HN-237
EN-79
NN-007

SERVICE BULLETIN

FIREWALL FUEL FITTING MODIFICATION

Figure 2. Firewall Fuel Fitting Modification (Removal).

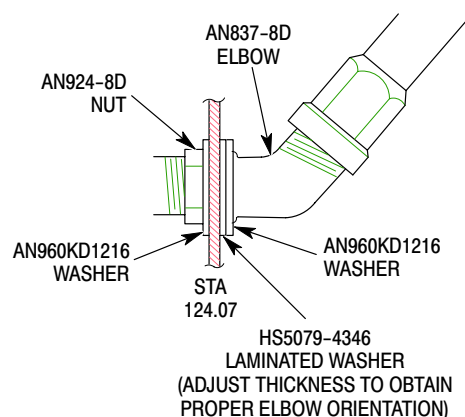
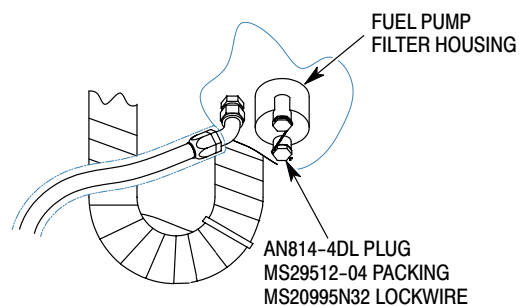
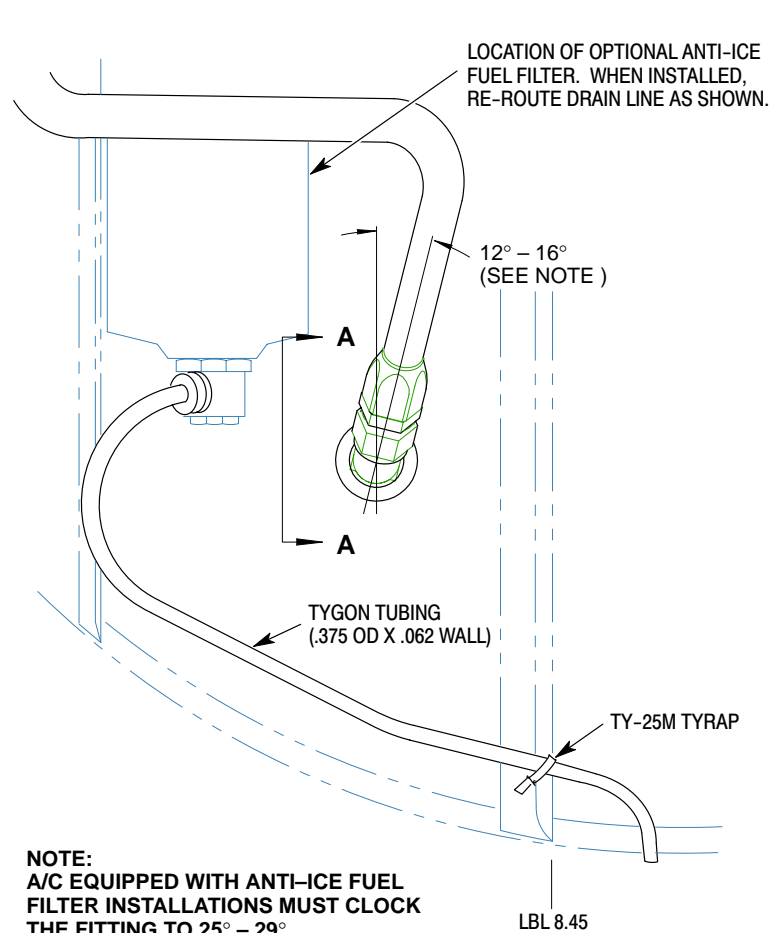
- (1). Refer to HMI Vol. I, Section 28-00-00 for access to fittings. This will require loosening the lacing supporting the fuel cell.
- (2). **If installed**, remove the following parts from the 369A8100-503, -505, -507, -509, -511, -703 and -705 fuel system installations: (see Figure 2)

MS24393D8	union, qty. 1
AN924-8	nut, qty.3
MS29512-08	packing, qty.2
369H8103	fitting, qty. 1
369D28099	drain valve, qty. 1 or 2
CAV-170-H4	drain valve, qty. 1 or 2
369A8010-85	tygon tubing
MS29512-04	packing, qty. 1 or 2
TY-25M	ty-rap
369A8100-3	tygon tubing
369A8100-5	tygon tubing
369A8100-7	tygon tubing
AN837-8D	elbow, qty. 1
MS24394D8	elbow, qty. 1
AN814-4DL	plug, qty. 1
AN939-8D	elbow, qty. 1
6151-0250	tee, qty. 1

Figure 1. Firewall Fuel Fitting Modification (Installation).

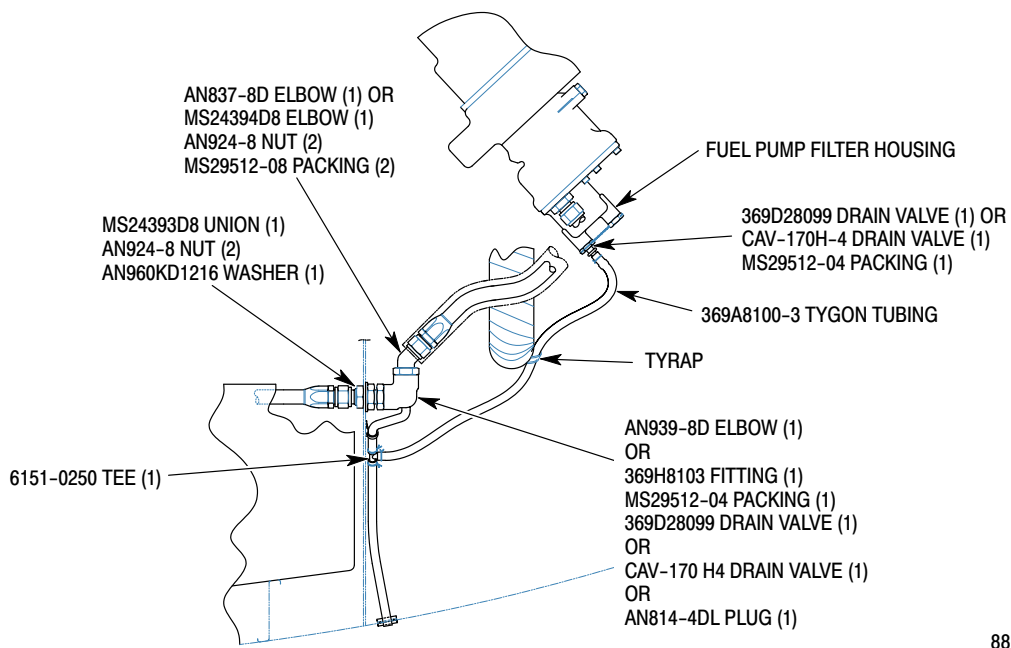
MDHI has received reports from the field of the station 124 firewall fuel fitting interfering with the landing gear brace. As a result, there is a possibility of the fuel fitting becoming damaged, thus creating a potential for fuel leakage. Therefore, MDHI is requiring all operators to modify their aircraft according to procedures contained in this Notice.

Operators are required to install an AN837-8D elbow at station 124.00 and remove the drain valve from the engine fuel pump filter housing.

- (3). Install AN924-8D (nut), (2) AN960KD1216 (washers), HS5079-4346 (laminated washer) and AN837-8D (elbow) as shown in Figure 1.
- (4). Ensure that AN837-8D is clocked 12° to 16° (25° to 29° for fuel systems equipped with anti-ice fuel filter installations) inboard as shown in Figure 1.

- (5). Reassemble fuel cell lacing per the HMI Vol. I, Section 28-00-00.
- (6). Re-install hoses to the AN837-8D fitting (see Figure 1). Torque hoses per the HMI-CSP-2, Vol. I, Section 28-00-00.

- (7). Install AN814-4DL plug, MS29512-04 packing and MS20995N32 lockwire to engine fuel pump housing 369A8100-507 configurations only at location shown in Figure 1.
- (8). Re-fuel aircraft per servicing instructions contained in the Handbook of Maintenance Instructions (HMI).

NOTE: HS5079-4346 shim thickness may be adjusted to obtain proper elbow orientation.
